FLEX & Un iFLEX

Modification F802

Block step puls when write signal active.

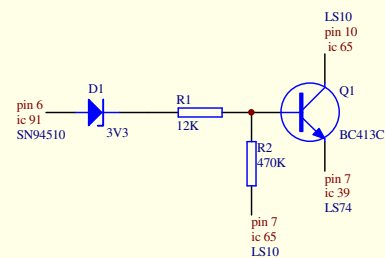
Cut jumper "K"., enable DS format SS diskette.
Keep jumpers C, D, F, M, X.
